ADDENDUM NO: 3

PROJECT: BCSC Columbus East High School – C4 Addition

PROJECT NO: 2025022 DATE: 11/10/2025 BY: Josh Cannaday

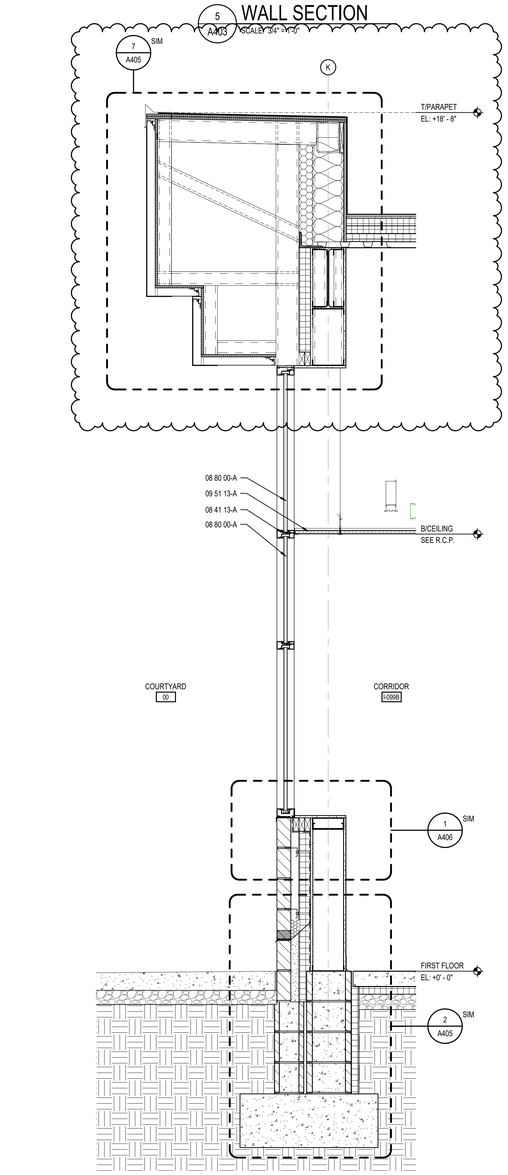
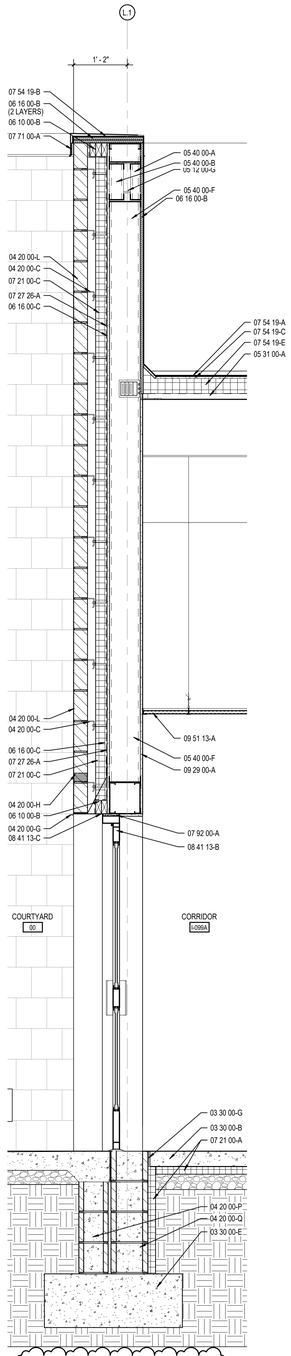
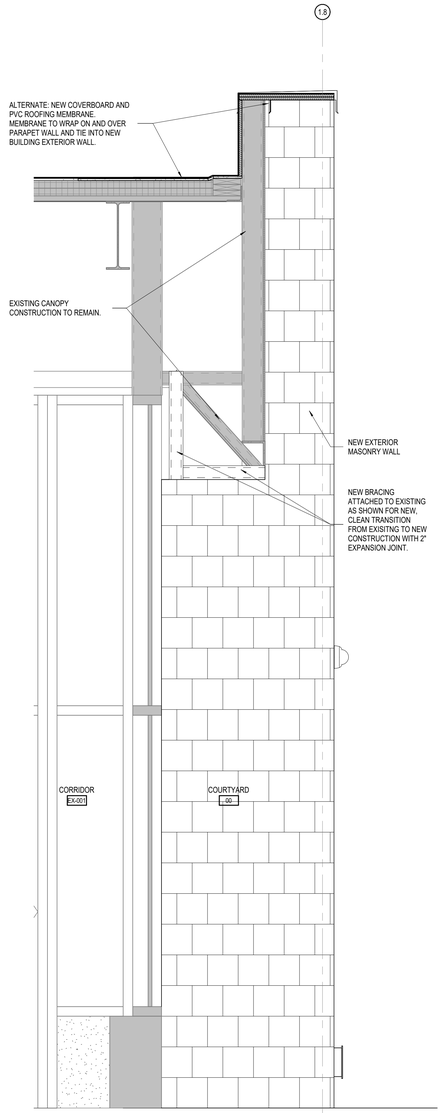
3.18 SHEET A403 – WALL SECTIONS

A. Revise wall section 3/A403 to reflect stud size changed from 10" to 8"

B. Revise wall section 2/A403 to remove expansion joint location from section

C. Revise wall section 4/A403 to reflect stud size change from 10" to 8" at top of wall section.

8 A406 ENLARGED SECTION DETAIL

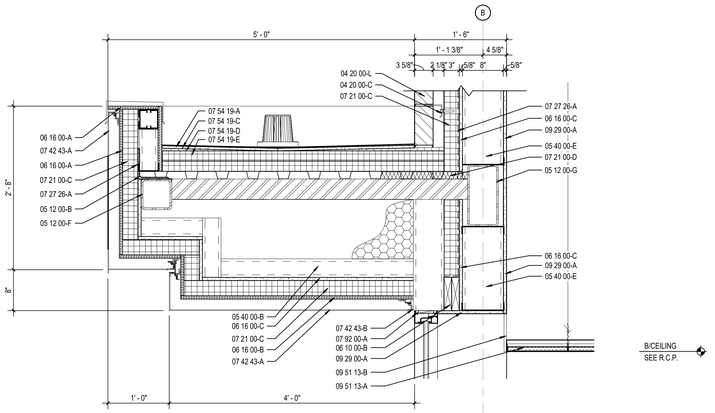
3.20 SHEET A406 – WALL SECTION DETAILS

A. Add Enlarged Section Detail 8 to sheet

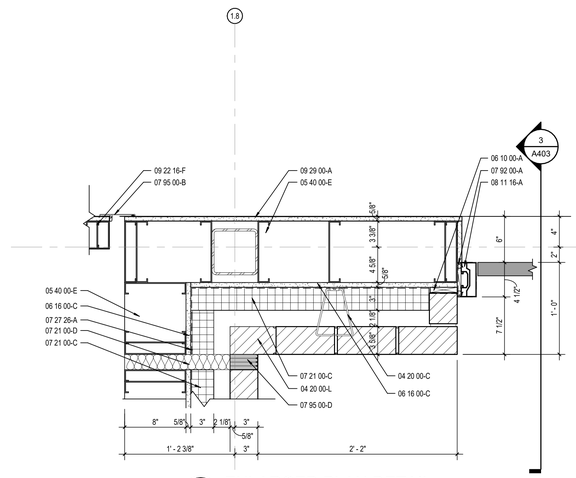
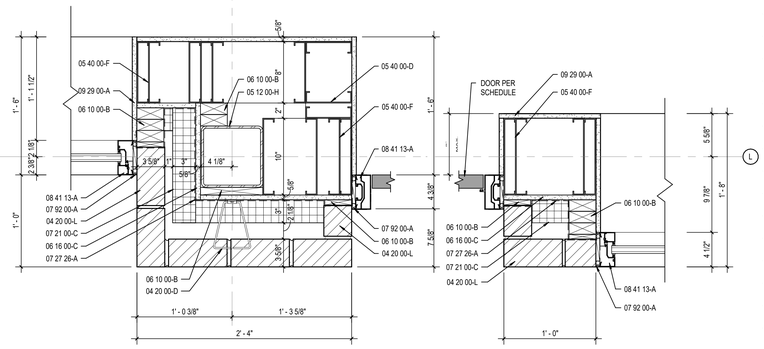
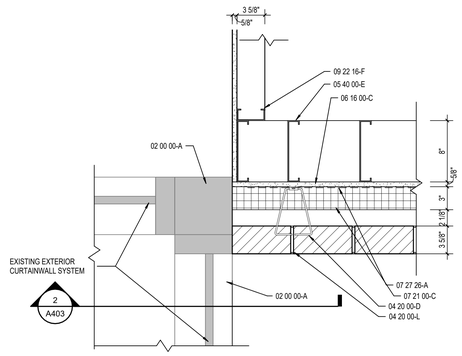
3.21 SHEET A410 – PLAN DETAILS

A. Add annotations to Enlarged Plan Details 4, 8, 9, & 10 on sheet

B. Revised plan details 1, 7, 8 on sheet for stud sizing change and for expansion joint location change

1 A801 FIRST FLOOR FINISH PLAN
SCALE: 1/8" = 1'-0"

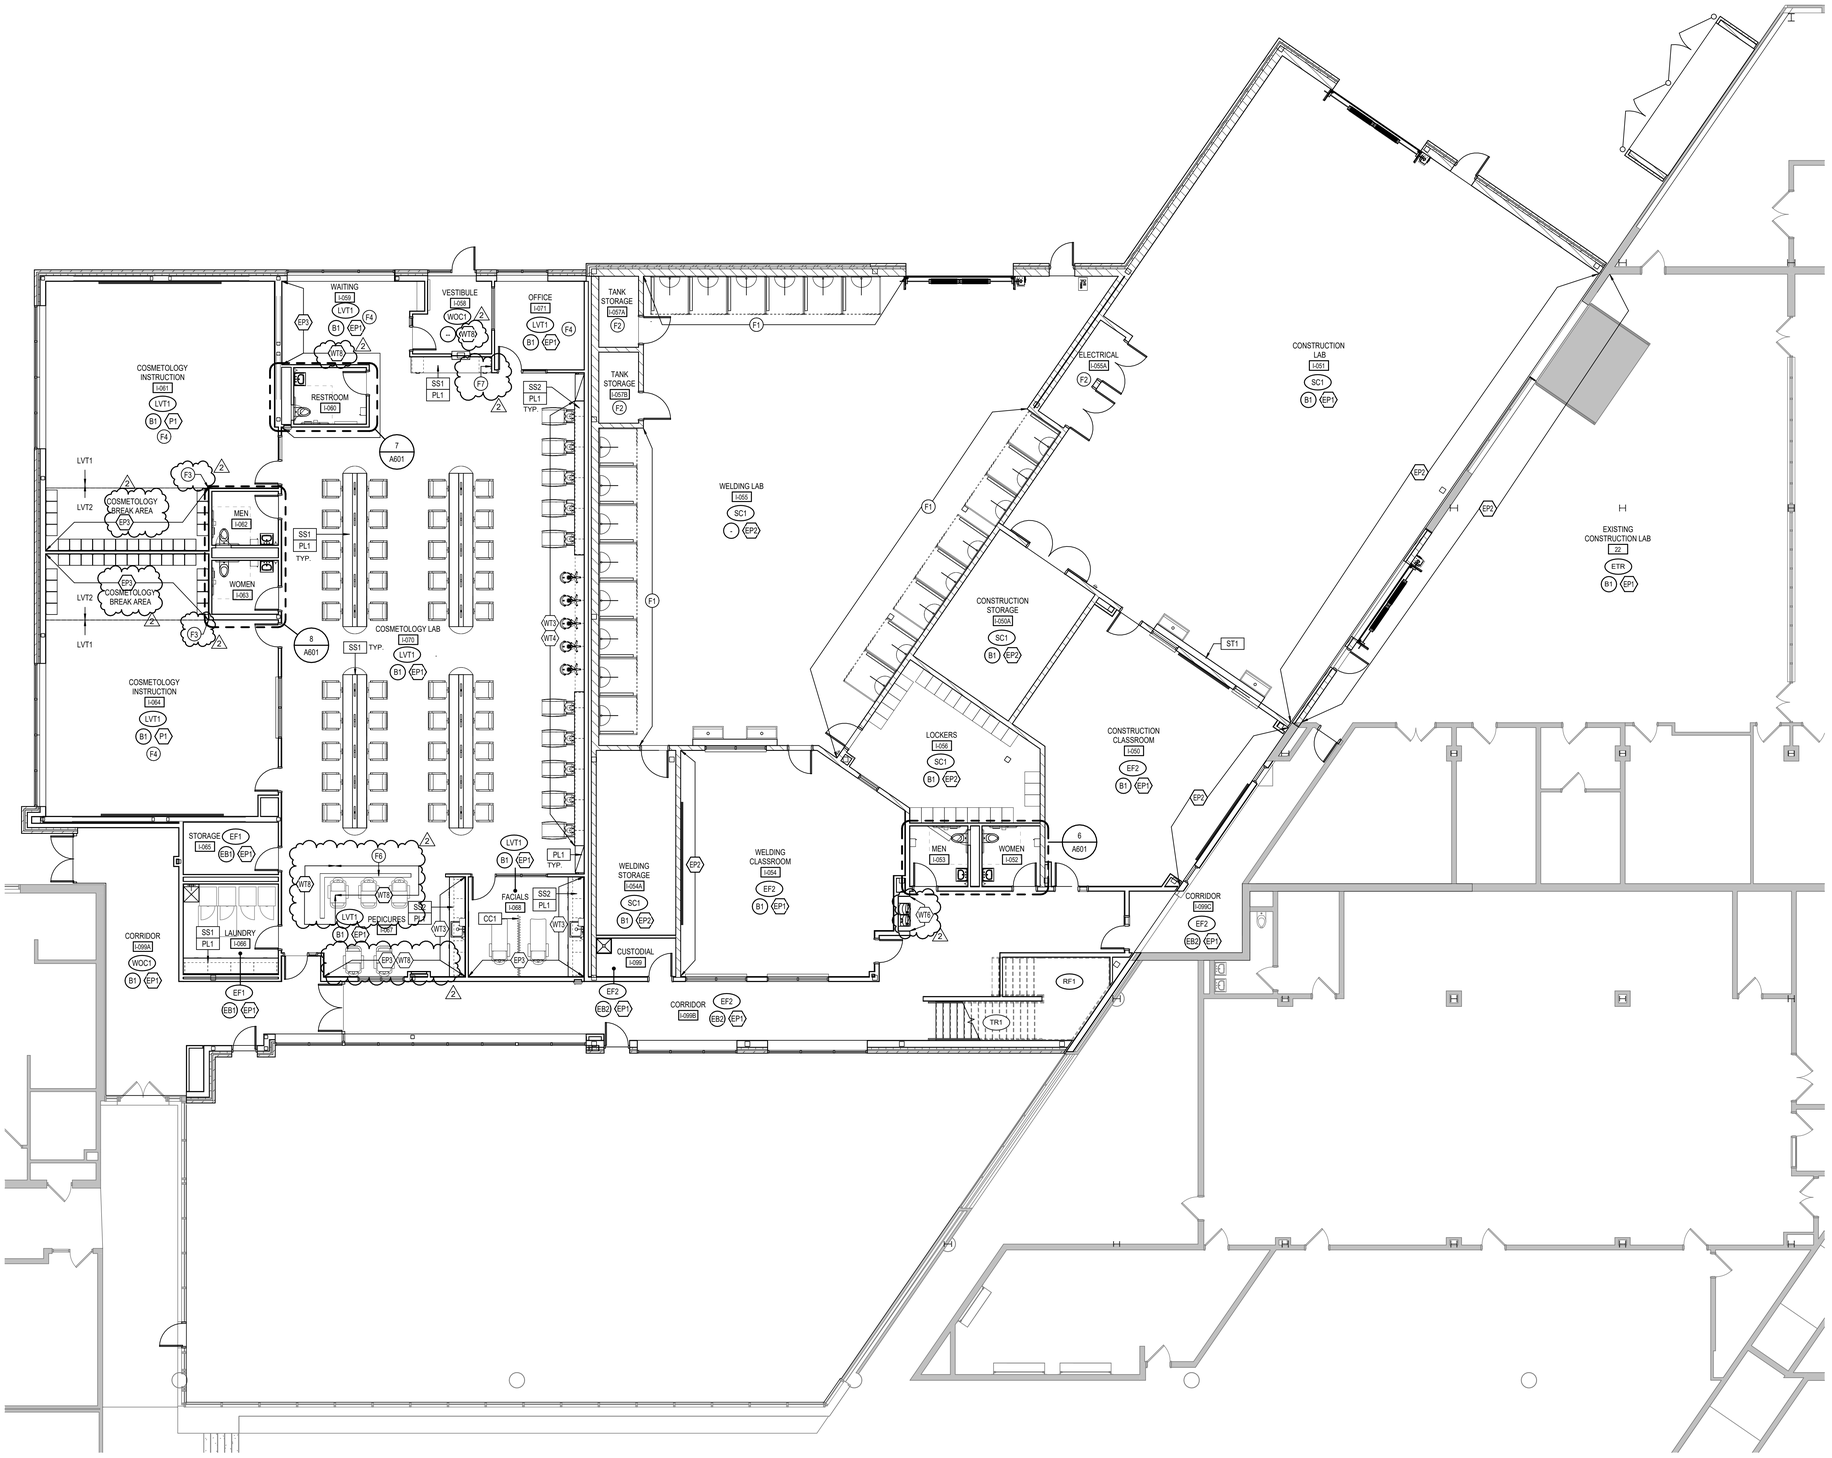
3.24 SHEET A801 – FIRST FLOOR FINISH PLAN

A. Revise wall finish in Vestibule I-058

B. Revise wall finish in Waiting I-059

C. Revise accent paint locations in Cosmetology Instruction I-061 and I-064

D. Revise finish plan F3 location in Cosmetology Instruction I-061 and I-064

E. Revise wall finishes in Pedicures I-067

F. Add delineation line and tag for "COSMETOLOGY BREAK AREA" to floor plan

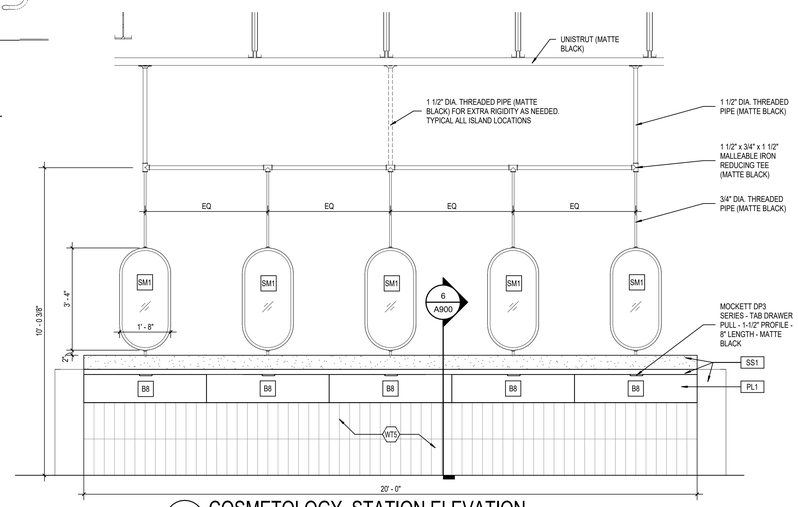
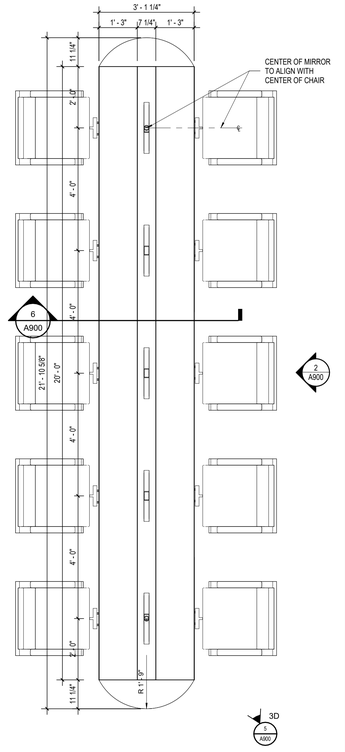
3.25 SHEET A900 – EQUIPMENT SCHEDULE AND DETAILS

C. Add details and annotations to the following views: 1/A900, 2/A900, 4/A900, 5/A900, 6/A900, 7/A900, 8/A900

DRAWING NUMBER
A901

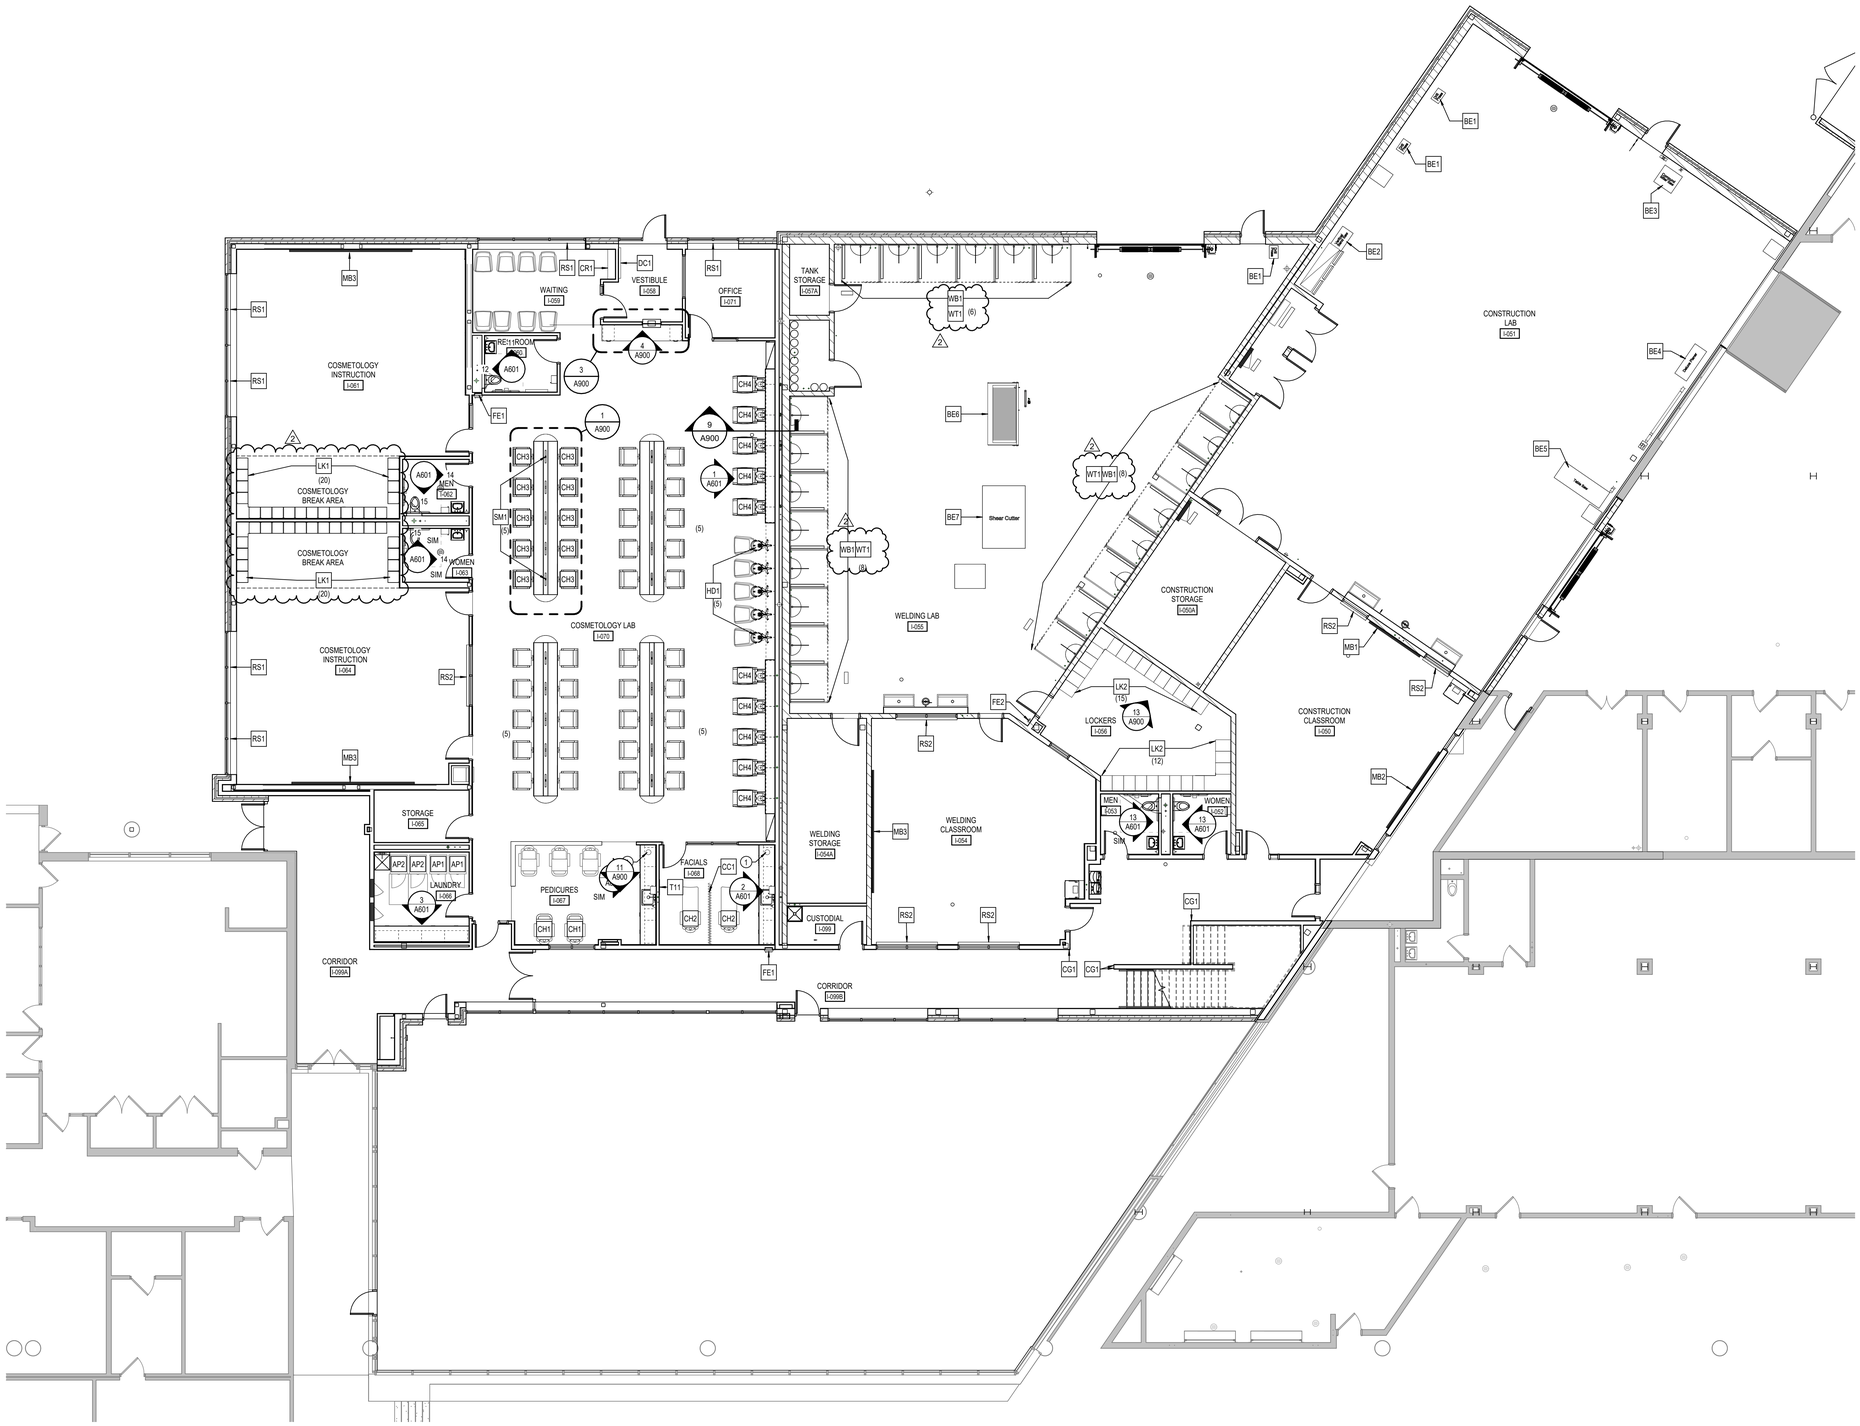
3.26 SHEET A901 – FIRST FLOOR EQUIPMENT PLAN

A. Add delineation line and tag for "COSMETOLOGY BREAK AREA" to floor plan

1 A902 SECOND FLOOR EQUIPMENT PLAN

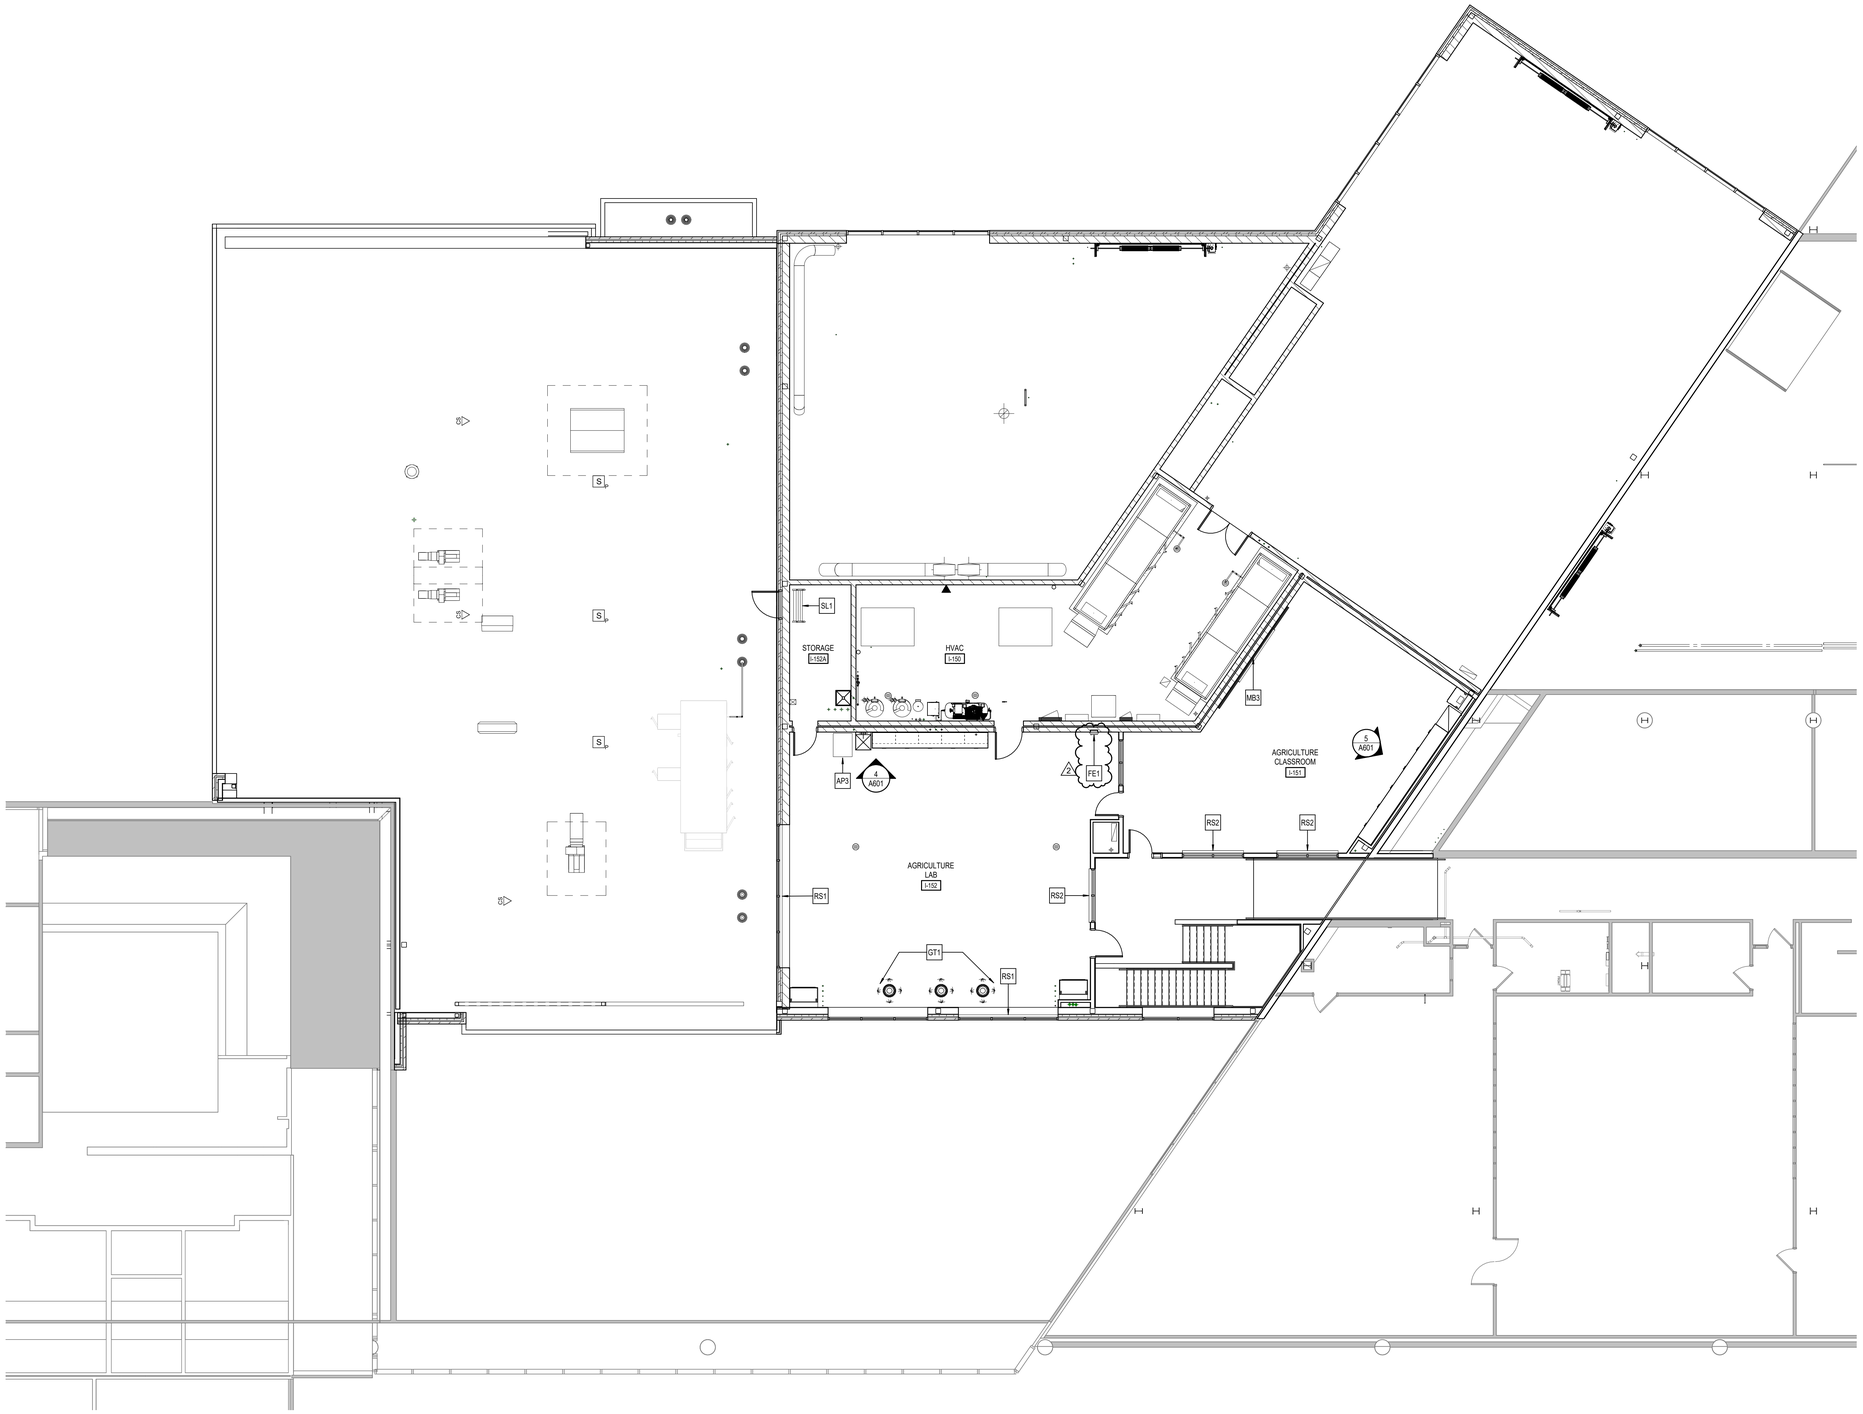
3.27 SHEET A902 – SECOND FLOOR EQUIPMENT PLAN

A. Add FE1 tag to fire extinguisher cabinet in Agriculture Lab I-150
